APPLICATION FOR CONDITIONAL USE PERMIT

Case No. 87-67- CUP

Mr. M Food Store
Rockwall, Texas

SITE PLAN REVIEW

Site Plan

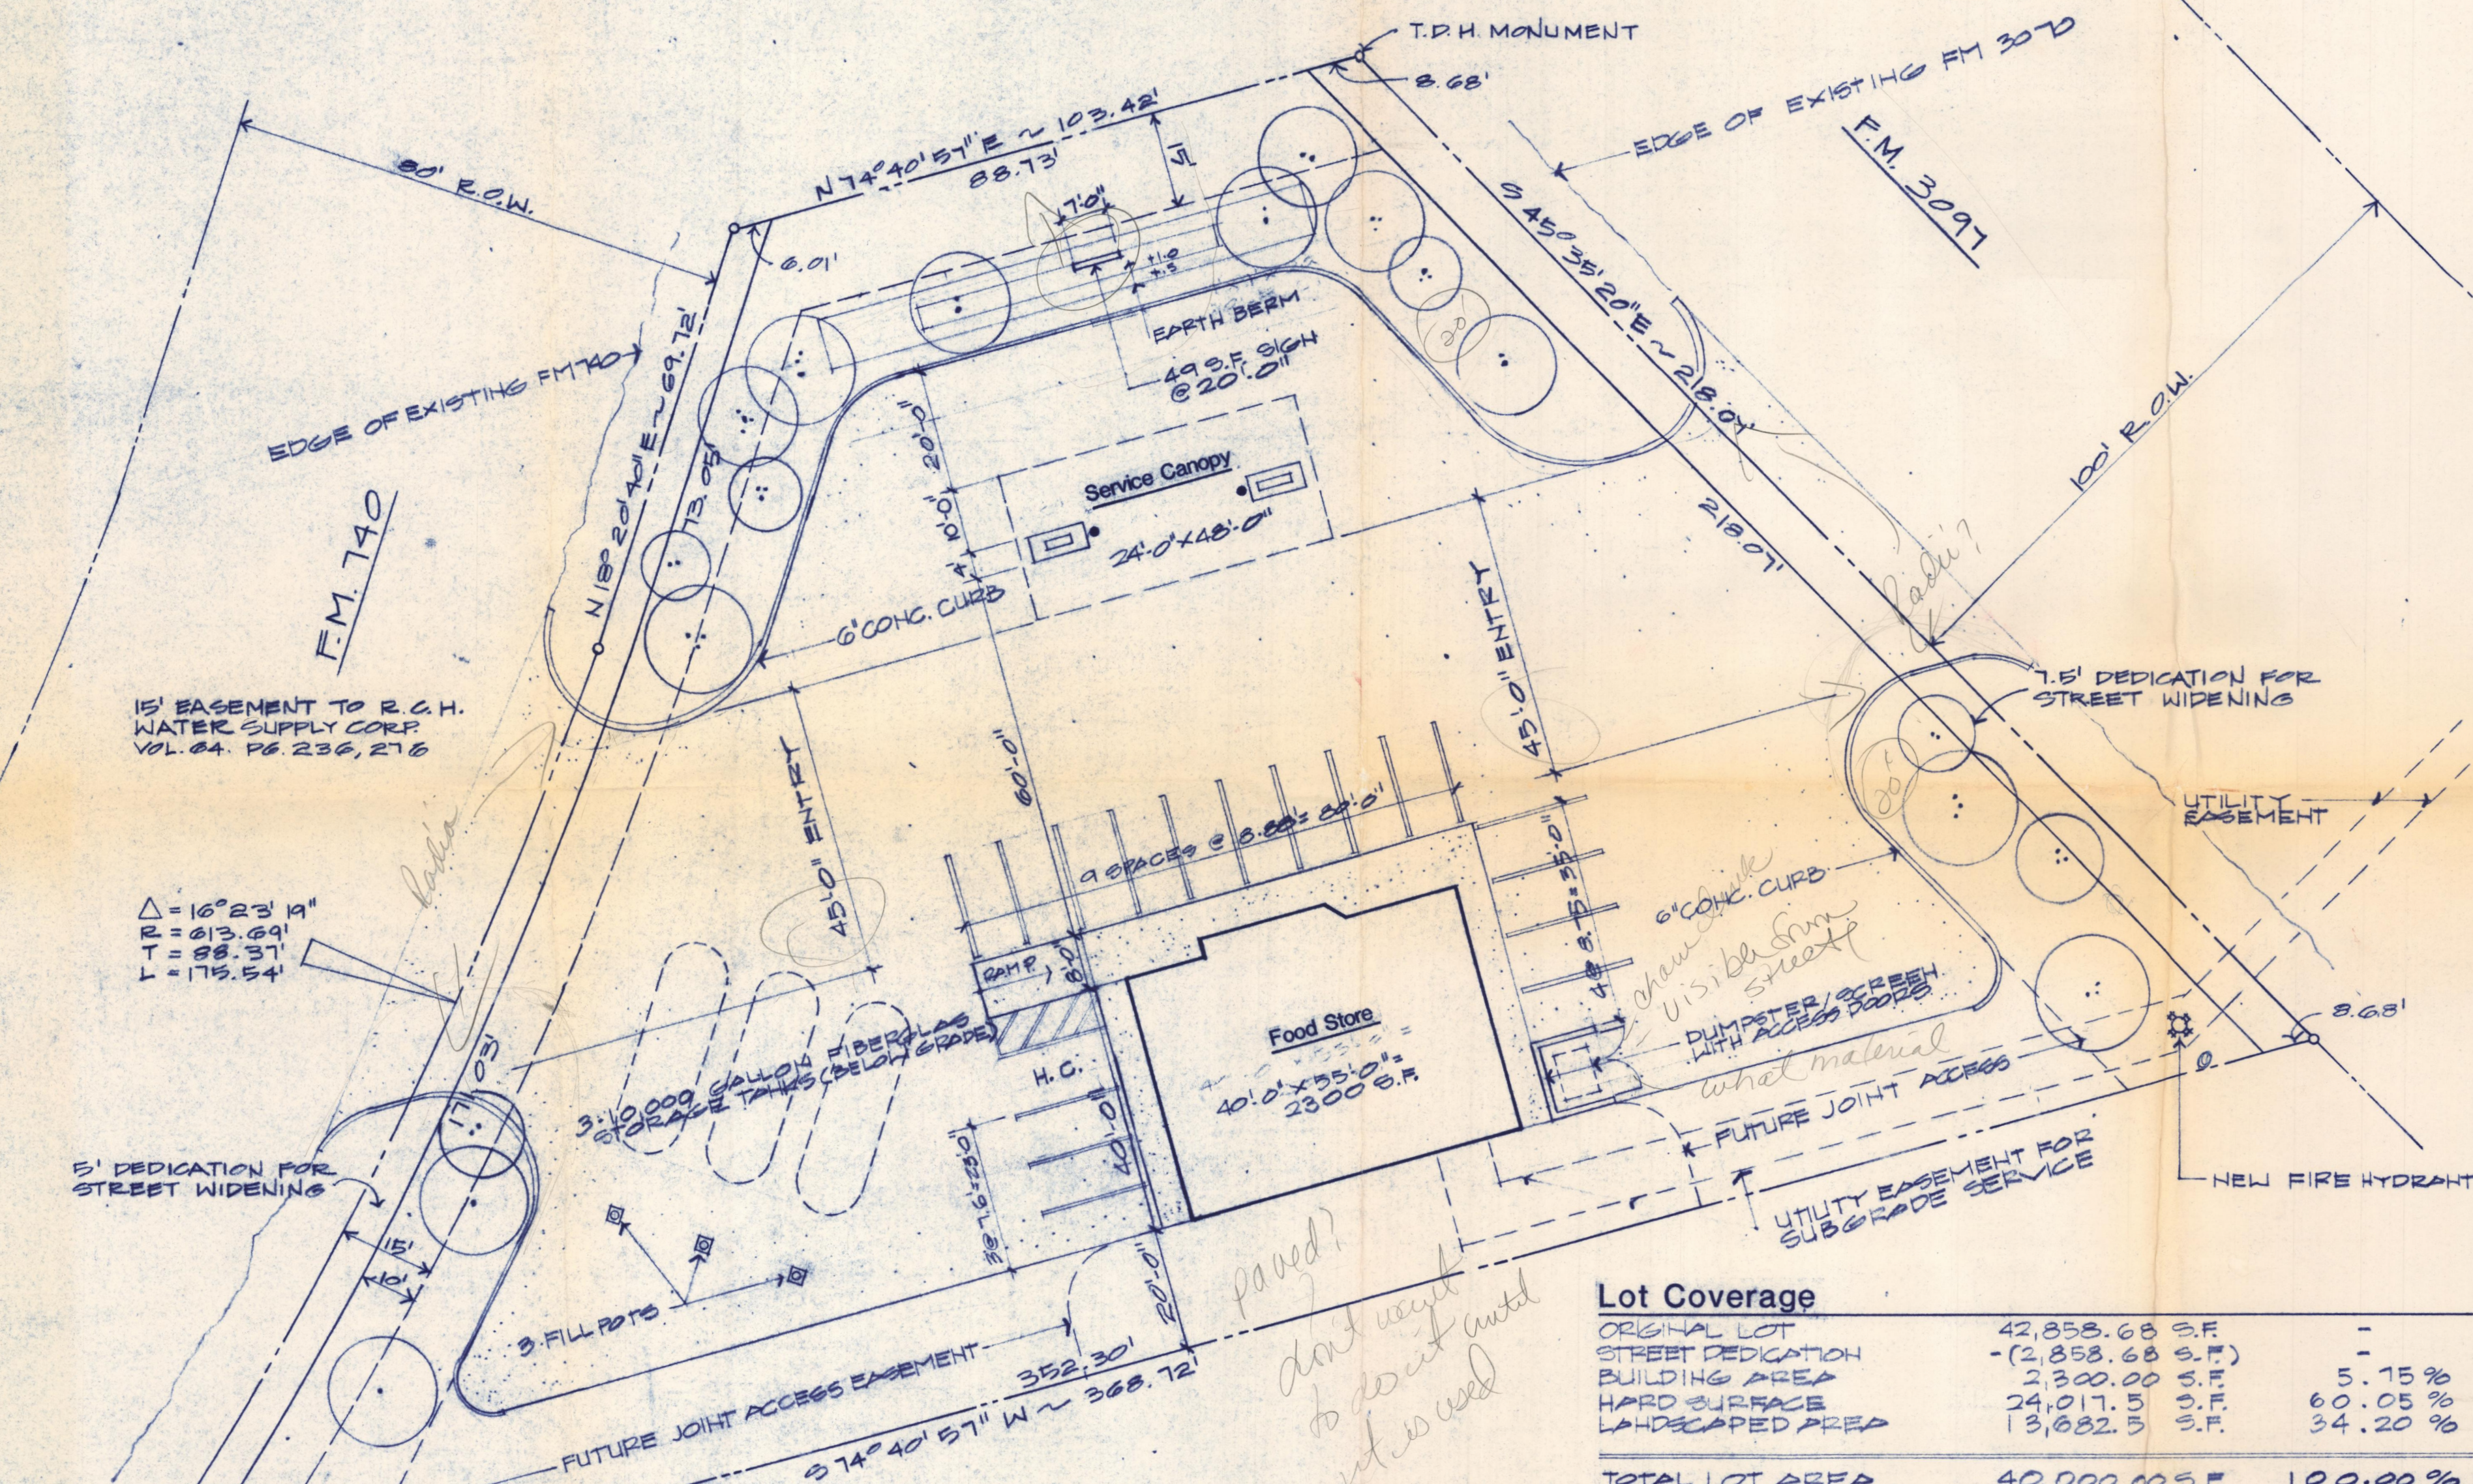
p. Are parking spaces dimensioned properly	☐	☐	☐
<i>9x18</i> ✓			
q. Does the parking lot meet City specifications	☒	☐	☐
r. Is a fire lane provided?	☐	☐	☐
<i>need to indicate fire lane on plan</i>

s. Is it adequate in width?	☐	☐	☐
t. Are drive entrances properly spaced? ✓	☒	☐	☐
u. Are drive entrances properly dimensioned? ✓	☐	☒	☐
<i>too wide</i> ✓			
....Do drive entrances line up with planned median breaks?	☐	☐	☒

v. Is lighting provided and correctly directed?	☐	☐	☐
<i>what about?</i>			
w. Are sidewalks required?	☐	☐	☐
<i>need sidewalks?</i>			
x. Are sidewalks provided?	☐	☐	☐

where are alc units? cannot be seen from street?
 dumpster screen - Buck?
 utility service - electric - underground?
 entrances too wide
 need to dedicate cross access easements on plat

access easement - entrance on 740/3097?
 access into dumpster visible from street

Site Plan

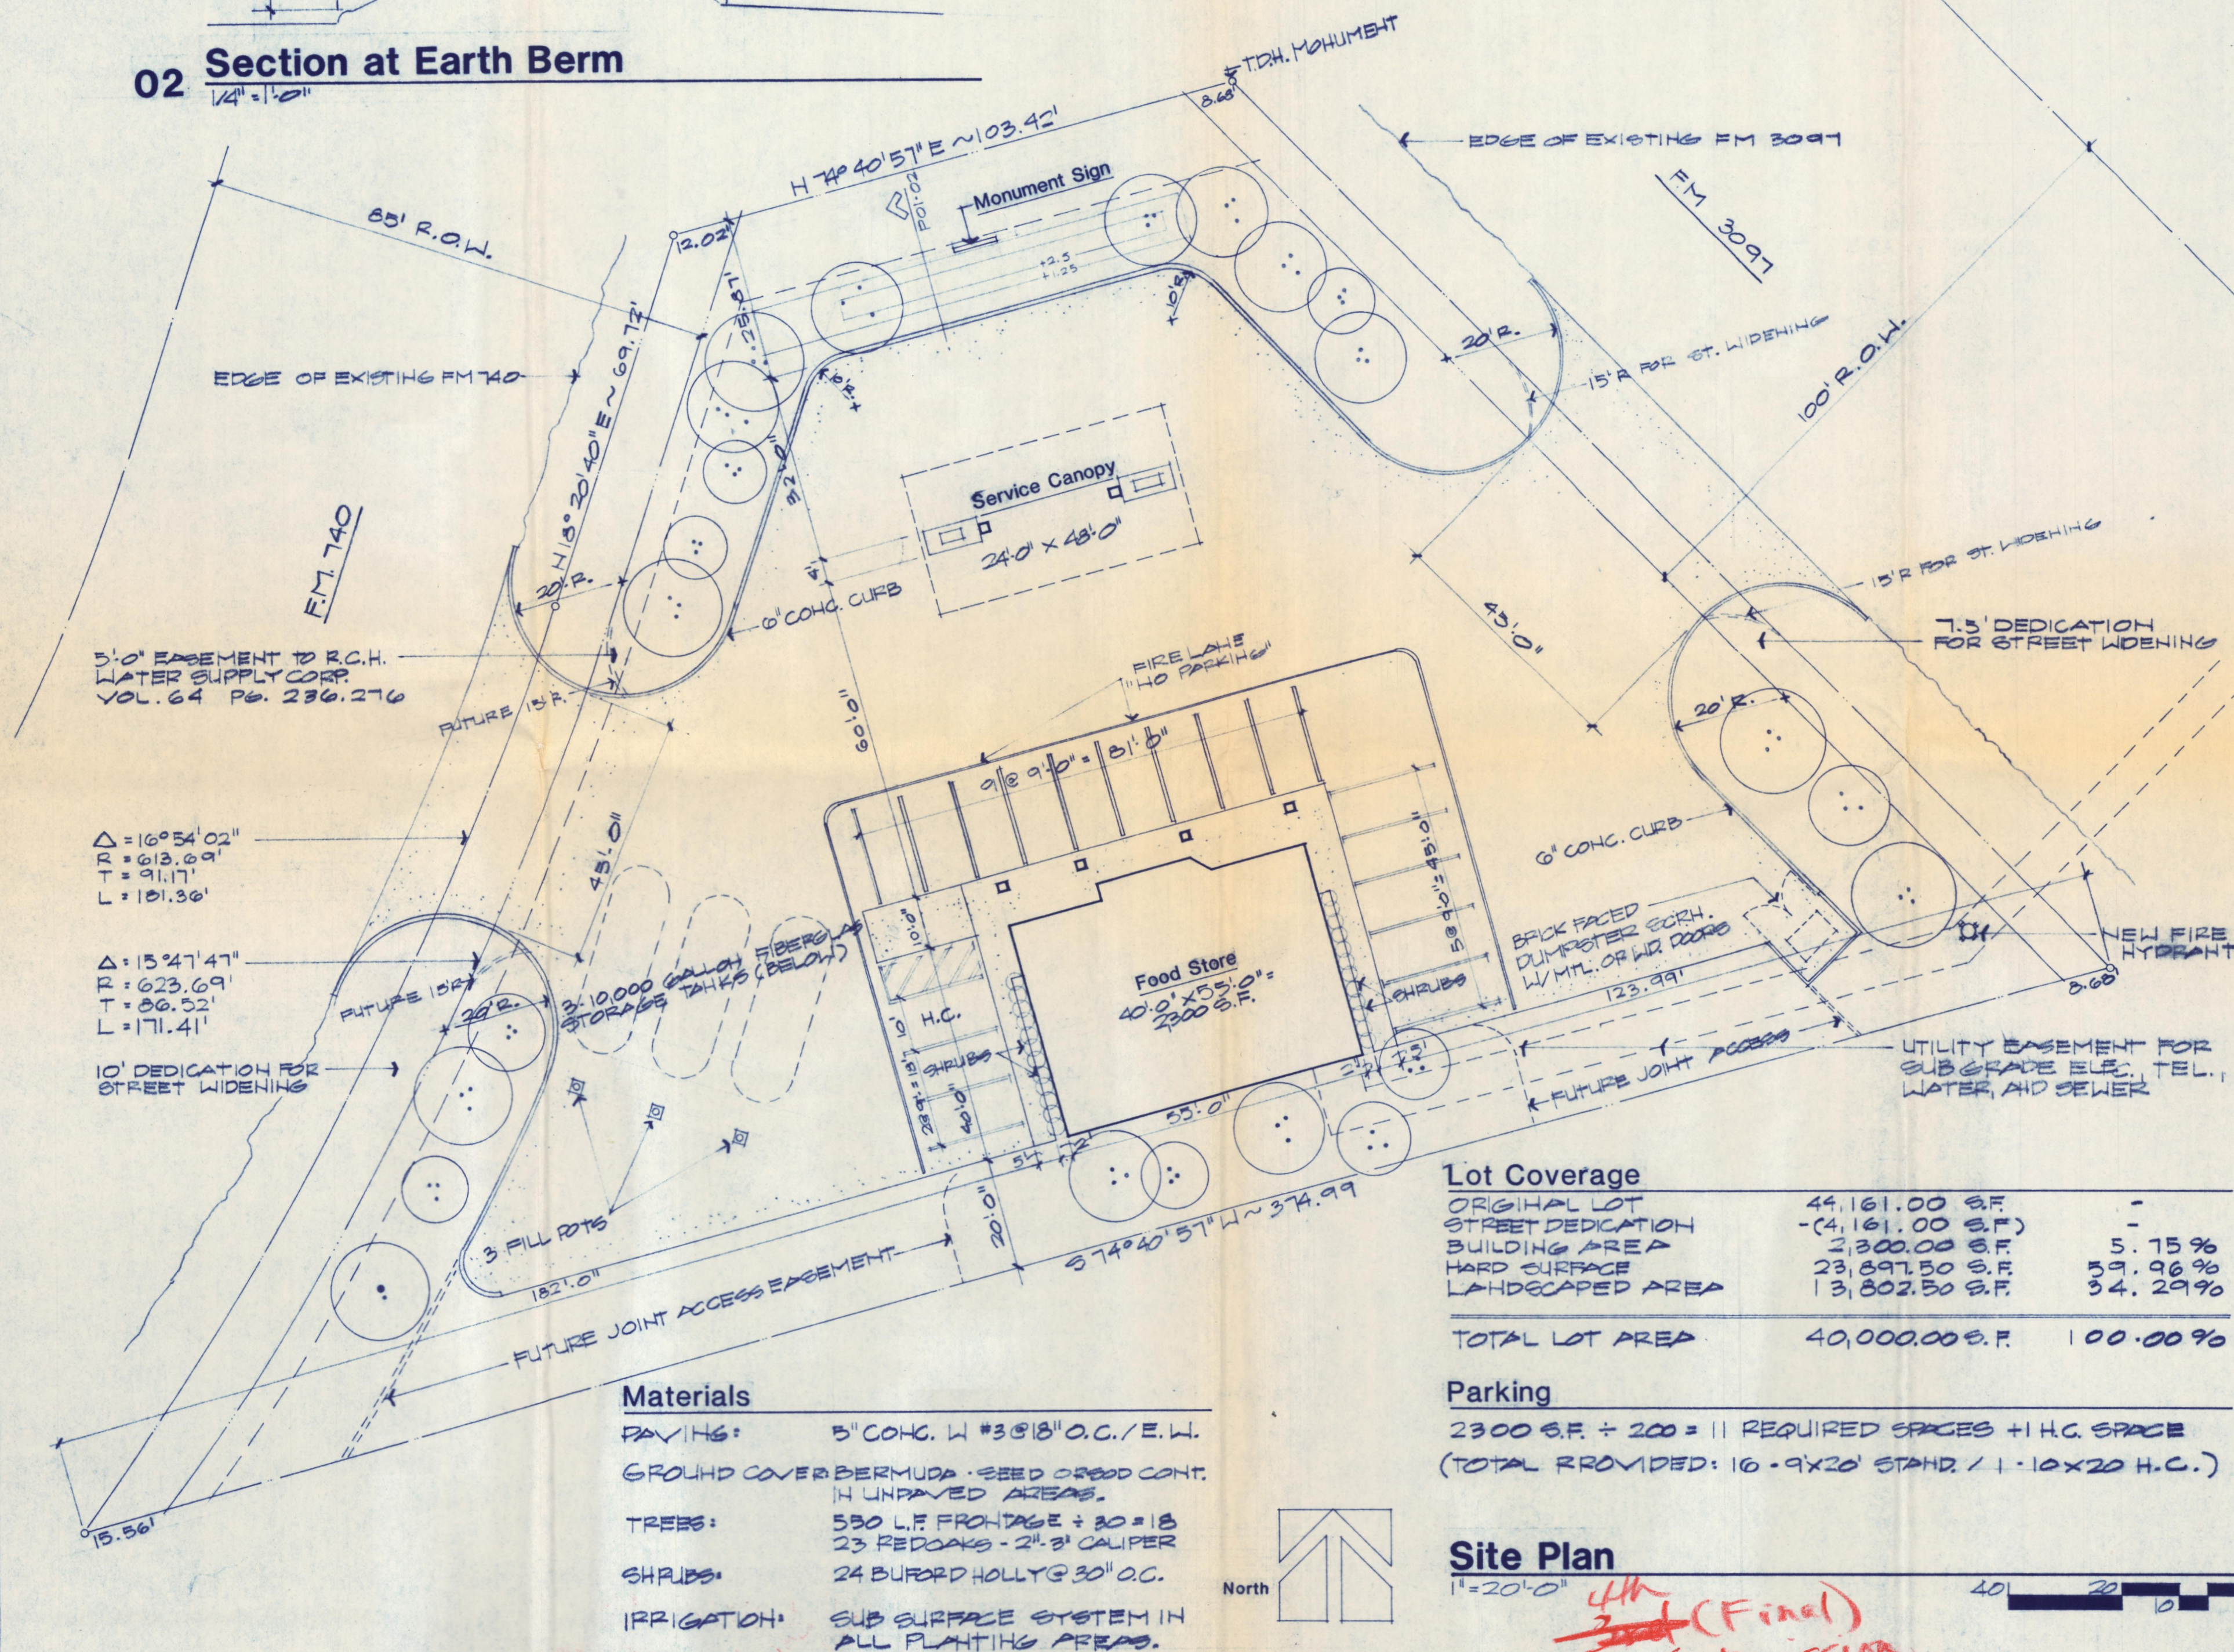
1. Consider moving the trash receptacle adjacent to the 20 foot landscape buffer, screened with a brick wall and planting, i.e., photinias and face the door to the building. This would more accurately meet the requirements of the District and would also, if it is faced at an angle, make access by a front loading trash truck easier.

2. Consider some vertical planting along the back of the building such as photinias that require little maintenance but would provide a break in the rear wall of the building.
3. Consider some requirements regarding the supports for the gas canopy. They are proposing the standard pole supports. Something similar to the brick treatment used by the Gulf Station that ties the canopy to the building might be more appropriate in the District.

- 1) move the proposed trash receptacle adjacent to 20 ft. landscaped buffer, screen with brick wall and planting facing toward the building
- 2) elevations to conform with photos shown of the Rowlett store including color of brick
- 3) the metal roof to be extended to all four sides of the building
- 4) property to rear of building to be landscaped with photinias
- 5) canopy support columns to be treated with brick
- 6) sidewalks on sides of building to be widened and landscaped with shrubbery adjacent to building.
